Monitoring Year 2 FINAL Monitoring Report
Stewarts Creek Tributaries Stream Restoration Project
Surry County, North Carolina
Yadkin River Basin, Hydrologic Unit Code (HUC) 03040101

NCDEQ Contract No. 7183
DMS ID No. 100023
RFP#16-006993
USACE Action ID No. SAW-2017-01508
DWR ID No. 20171043

**RE: Response to Draft Monitoring Year 2 (MY2) Monitoring Report Comments dated December 9, 2021
Stewarts Creek Tributaries Stream Restoration Project
Yadkin River Basin –HUC 03040101 – Surry County, North Carolina
NCDMS Project # 100023, Contract # 7183**

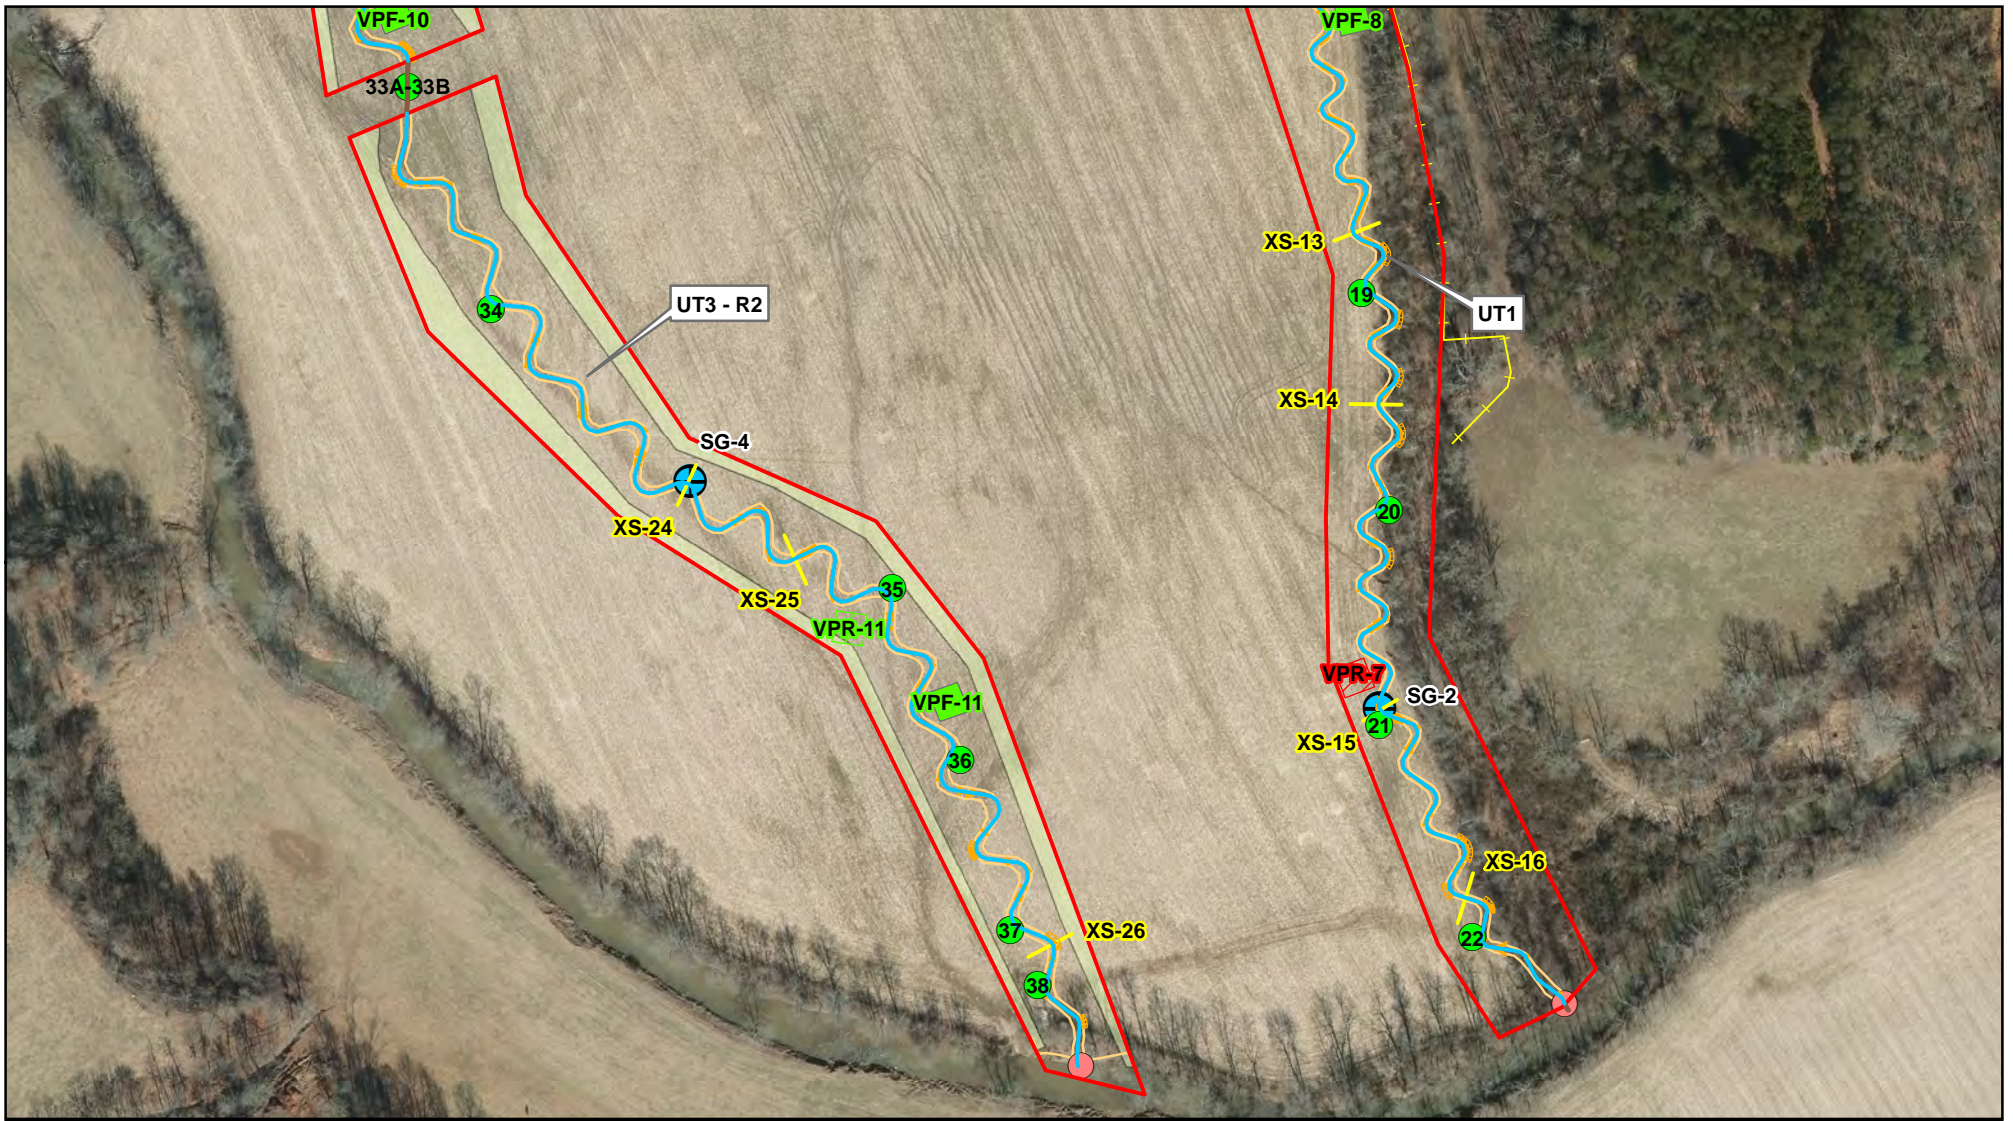
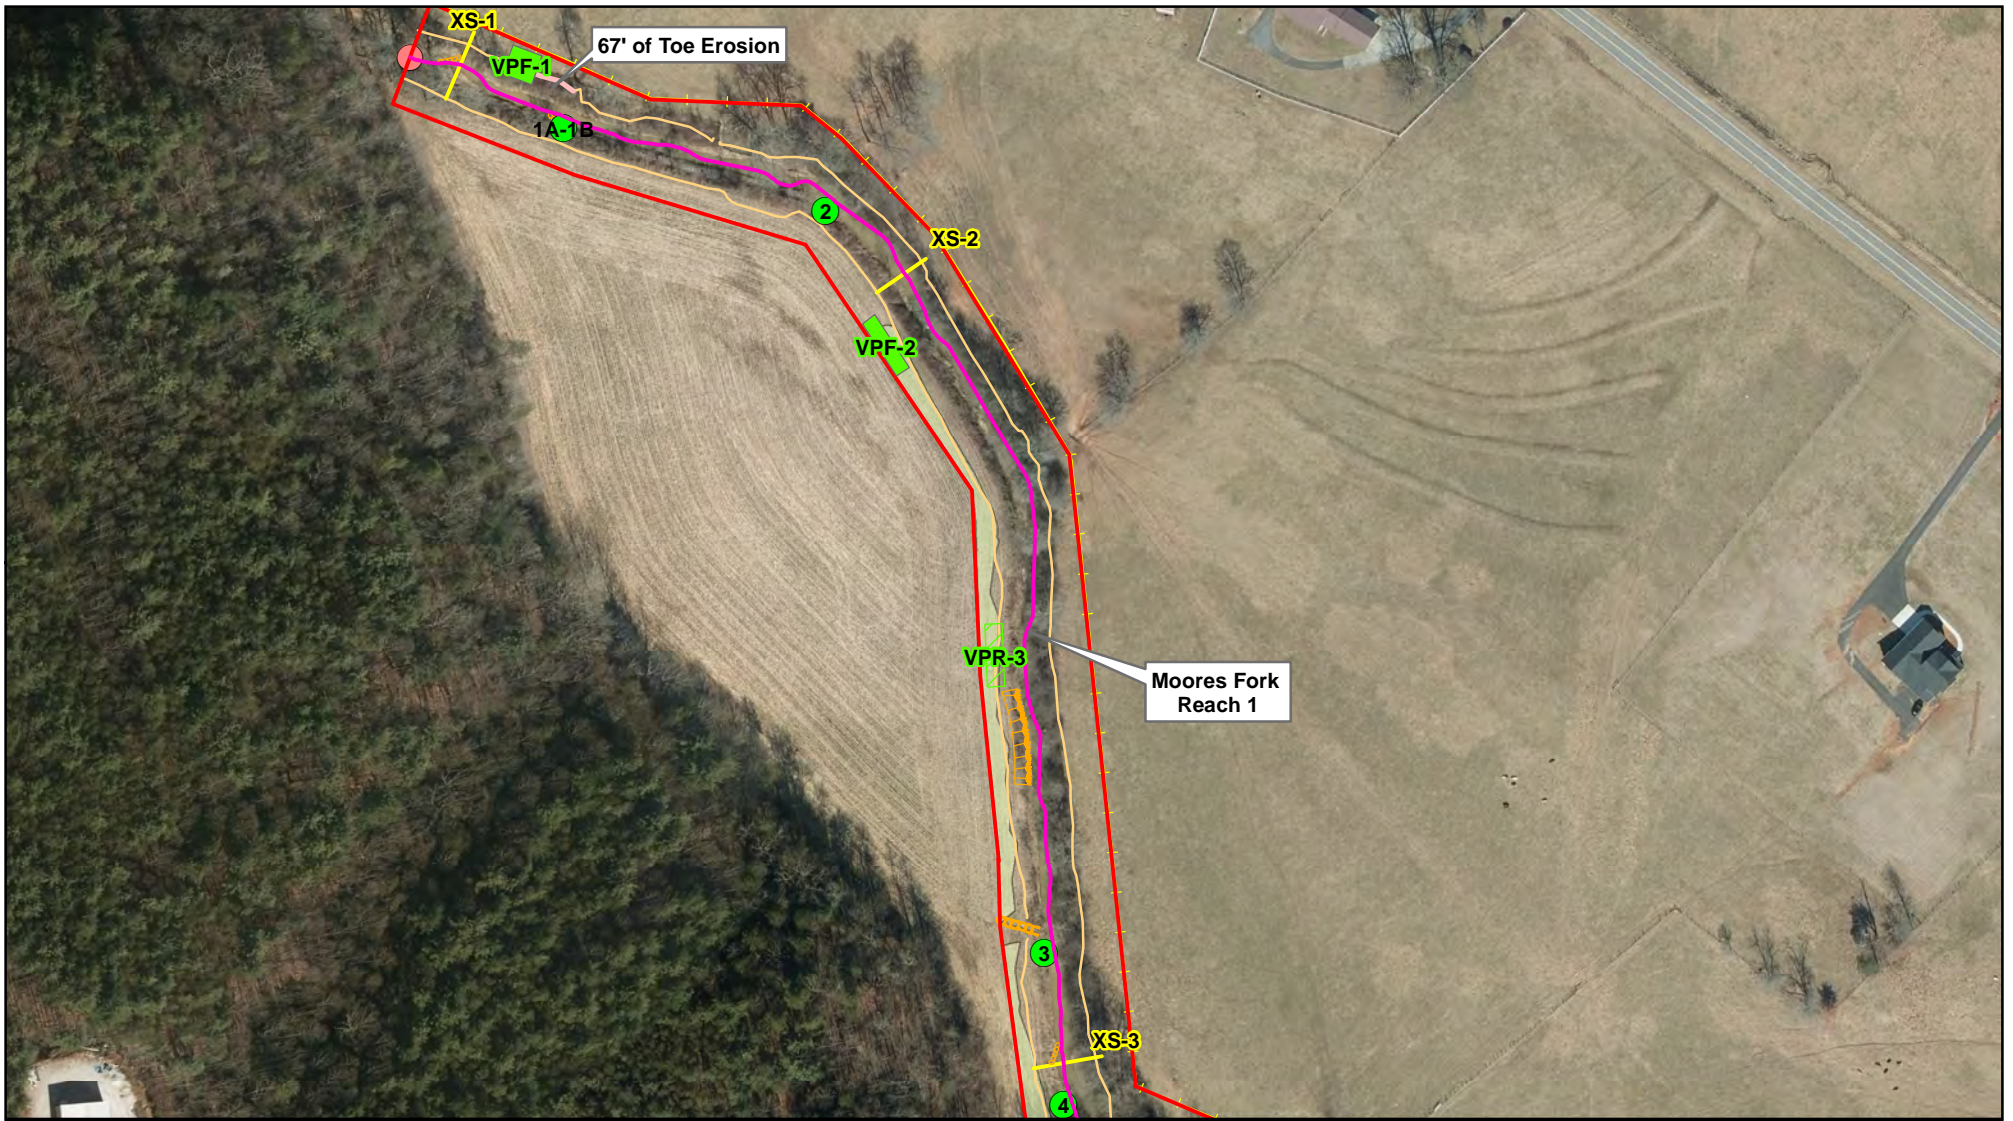
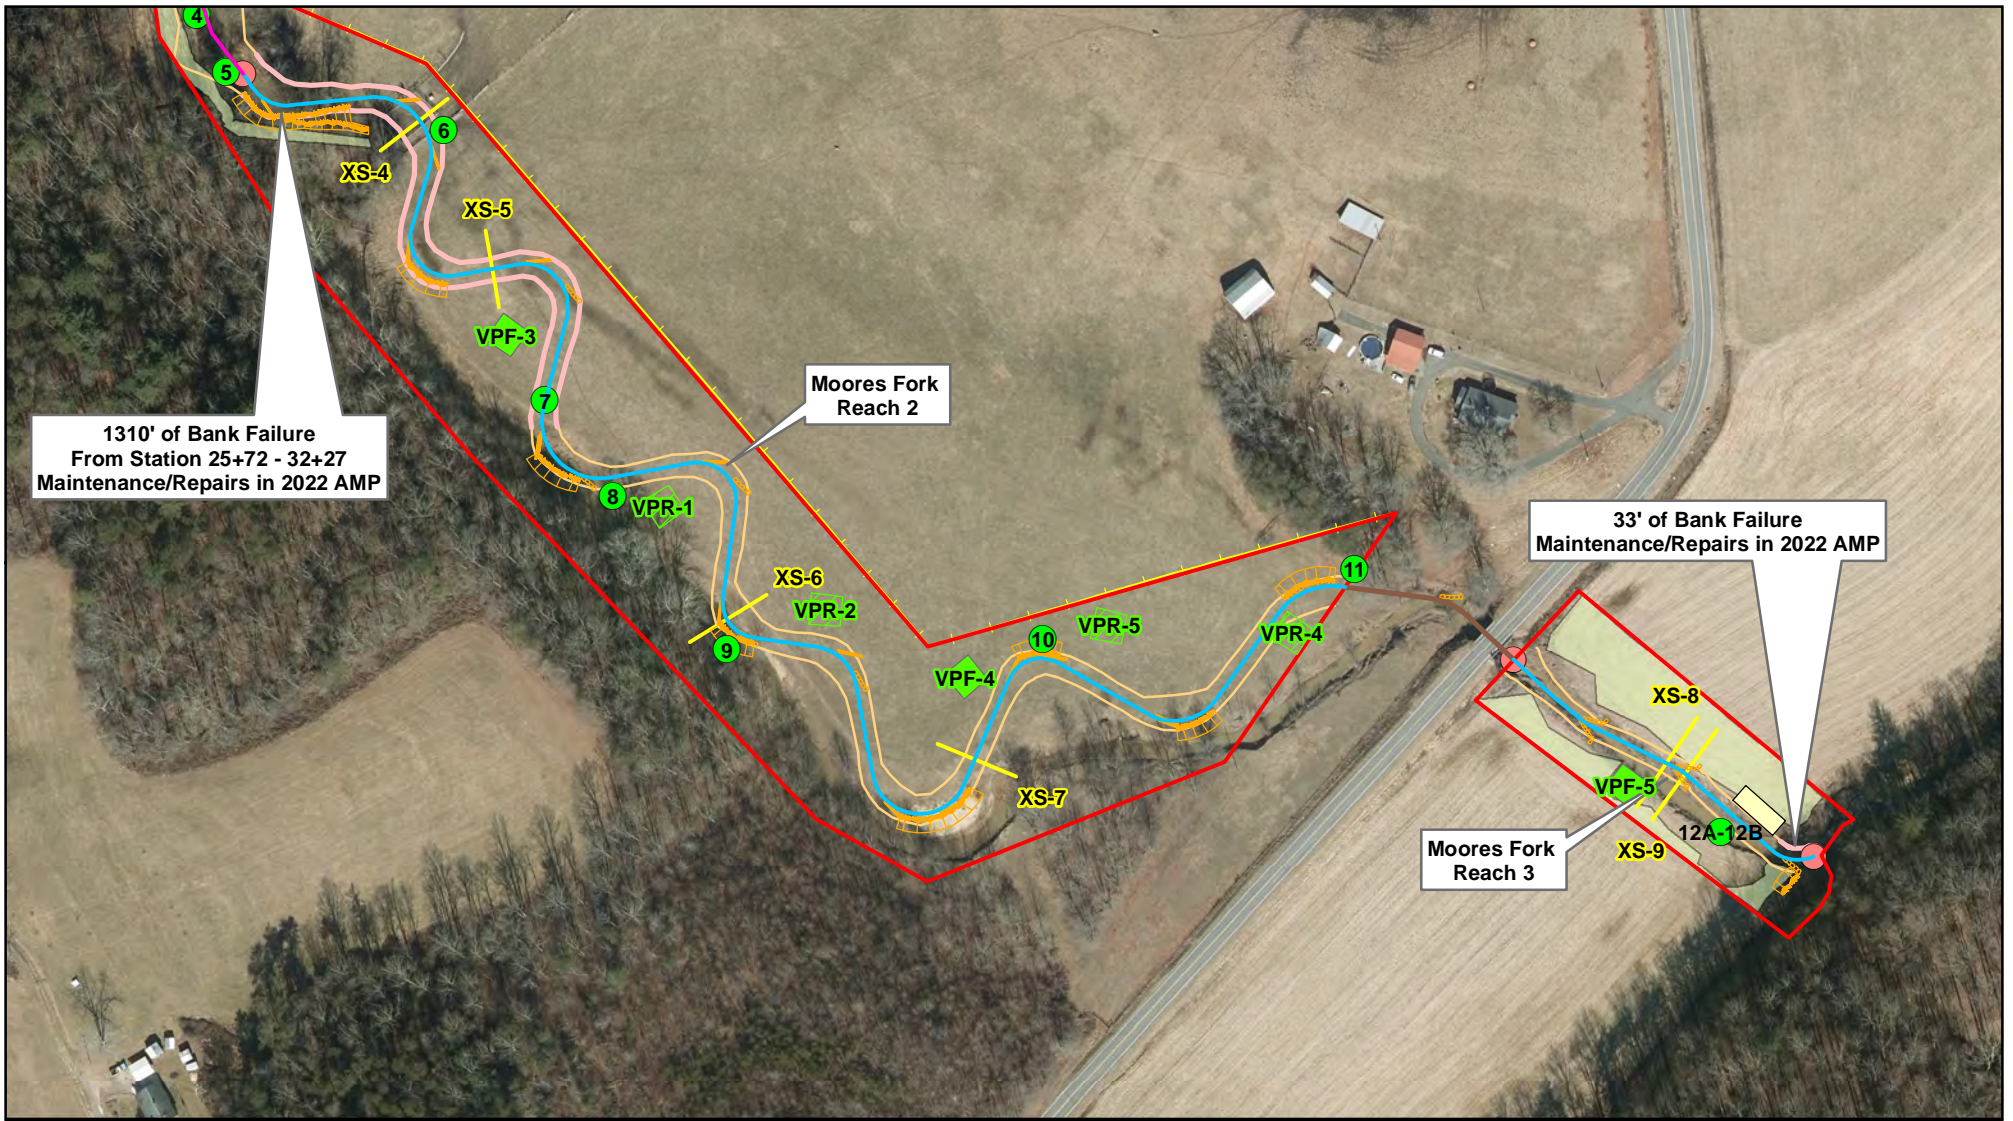
- *CCPV Maps: The MY3 interim success criteria for the project is 320 stems/acre. Please show any vegetation plots that do not meet the interim success criteria (VPR-7) as “red” on the CCPV Maps.*
 - **Updated.**
